CONSTRUCTION WORKS FOR LORIEN COLONIAL DAM WATER PROJECT

CLARIFICATION ON

Tender No: CRVWDA/LAIK/LOR-COL/DAM/20/2025-2026

Employer: Central Rift Valley Water Works Development Agency (CRVWDA), Nakuru, Kenya

Client:			Location:		
Surveyed By:			File Name:		Scale: AS SHOWN
Drawn By:			Project:		
Designed By:			Drawing Title:	SPILLWAY FOR SMALL EARTH DAMS	
Checked By:			Drawing No:	Rev:	Sheet:
Approved By:			TYPE DRAWING II		3/17

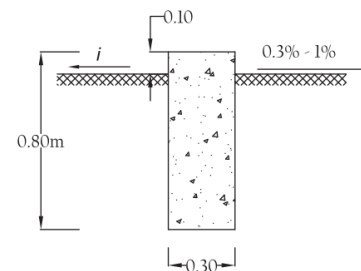
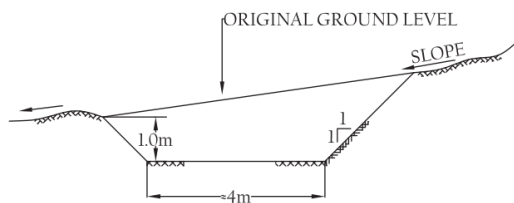
<p>3 Please refer to BoQ items 2.5 to 5 and kindly provide / clarify the following:</p> <p>a. BoQ item 2.5: standard drawing / section view on the deep excavation and embankment.</p> <p>b. BoQ item 2.6: drawing / section view on the core trench works with specifications.</p> <p>c. BoQ items 2.8.1, 2.8.2 and 2.8.3: standard drawing for the spillway channel, including stone pitching slope protection and concrete protection sills.</p> <p>d. BoQ item 2.8.4 has no unit of measurement nor quantity. We understand that these works are not required and the item shall not be priced / not included in our bid. Please, kindly confirm or clarify.</p> <p>e. BoQ item 2.8.5: drawing where the culvert 900mm shall be placed, including the bedding details, etc.</p> <p>f. BoQ items under section 2.9: standard drawings of the Draw-off system.</p> <p>g. BoQ item 2.10.1: standard drawings of the valve chamber.</p> <p>h. BoQ items under section 3: layout drawing of the planned construction of cattle through and pipelines layout.</p> <p>i. BoQ item 4: please, indicate location, applicable standard drawings and specifications for the construction of the community water point.</p>	<p>a. BoQ item 2.5 (Deep excavation and embankment): Use standard zoned embankment sections (core, filter, shoulders, slopes typically 2:1 to 3:1) as per Section VI Specifications and small dam design norms in Kenya. The information in the BoQ takes precedence</p> <p>b. BoQ item 2.6 (Core trench): Excavate to minimum 2m depth (or to impervious layer), backfill with suitable impermeable material, compact to 95% MDD. The information in the BoQ takes precedence</p> <p>c. BoQ items 2.8.1–2.8.3 (Spillway channel, stone pitching, concrete sills): Use standard spillway details with stone pitching on upstream/downstream slopes and Class 20/20 concrete sills at crest and toe. The information in the BoQ takes precedence. Check drawings attached in this clarification.</p> <p>d. BoQ item 2.8.4: This item is required and is to be priced at item 2.8.5 (900mm diameter culvert crossing). Quantity: 12 No. (main crossing). Not optional. Details per standard culvert installation.</p> <p>e. BoQ item 2.8.5 (Culvert 900mm): Placement in spillway channel. Use standard bedding/haunching (granular or concrete).</p> <p>f. Section 2.9 (Draw-off system): Use standard perforated offtake tower/pipe arrangement with valves. The information in the BoQ takes precedence. Check drawings attached in this clarification.</p> <p>g. Item 2.10.1 (Valve chamber): Standard 1.5m × 1.5m masonry chamber with lockable cover.</p>

Client:			Location:		
Surveyed By:			File Name:		Scale: I:40 OR AS SHOWN
Drawn By:			Project:		
Designed By:			Drawing Title: COMMUNAL WATER POINT		
Checked By:			Drawing No:	Rev:	Sheet: 7/17
Approved By:			TYPE DRAWING V

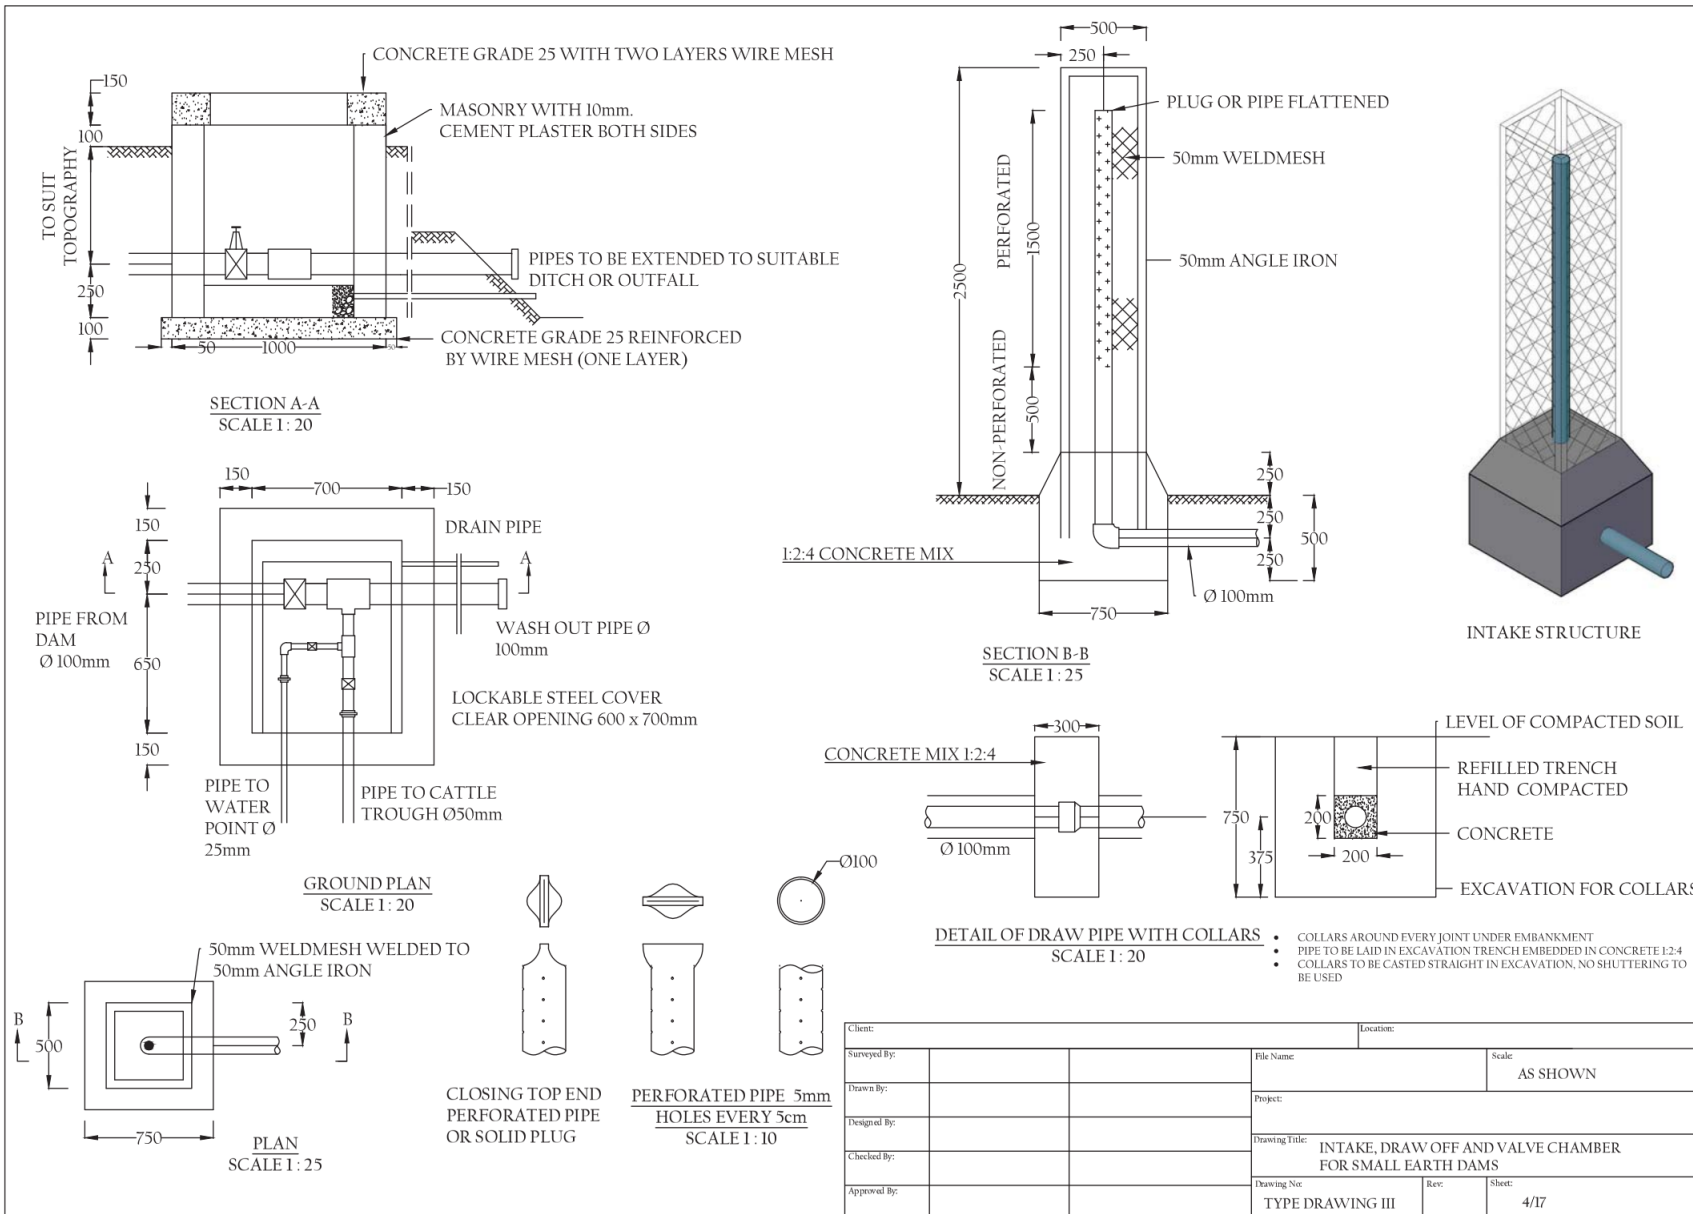
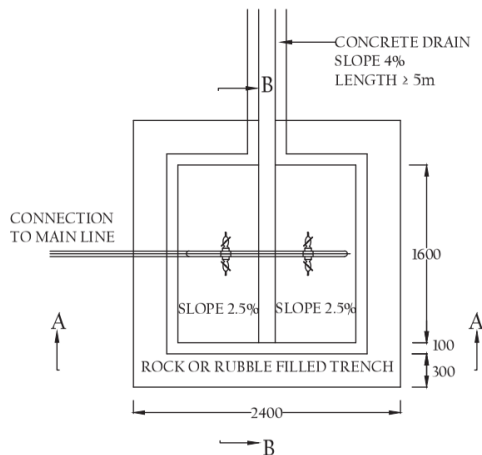
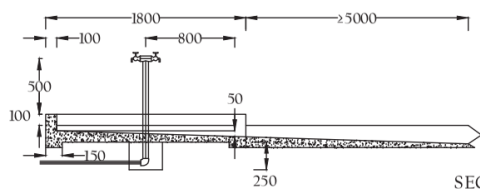
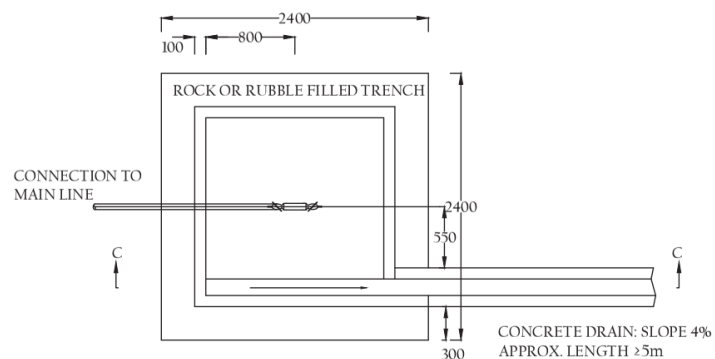
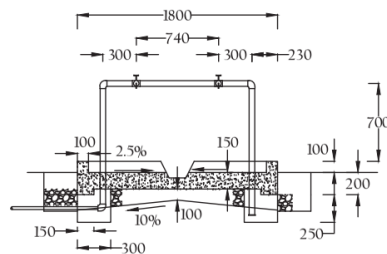
<p>j. BoQ items under section 5: standard drawings of fencing and gates.</p>	<p>h. Section 3 (Cattle trough and pipelines): Layout as per general site arrangement observed on site. Pipeline from draw-off to trough. Drawing as attached.</p> <p>i. Section 4 (Community water point): Standard CRVWWDA/Ministry of Water 4-tap communal point with soak pit. Location as shown during pre-tender visit.</p> <p>j. Section 5 (Fencing and gates): Standard 2.0m chain-link fence with 4m double gate. The information in the BoQ takes precedence</p> <p>❖ Check annexed drawings but the information in the BoQ takes precedence. Updated Drawings will be provided before implementation.</p>
4	<p>Please, kindly provide, if possible, any available information regarding the existing in-situ soil materials.</p>	<p>As stated in the Site Data provisions (GCC 14.1 and related clauses), tenderers are deemed to have inspected the site and conducted their own investigations. No additional detailed geotechnical information is provided at this stage. The reservoir area is described in the BoQ as soft/marshy material. Contractors are encouraged to undertake their own soil tests.</p>
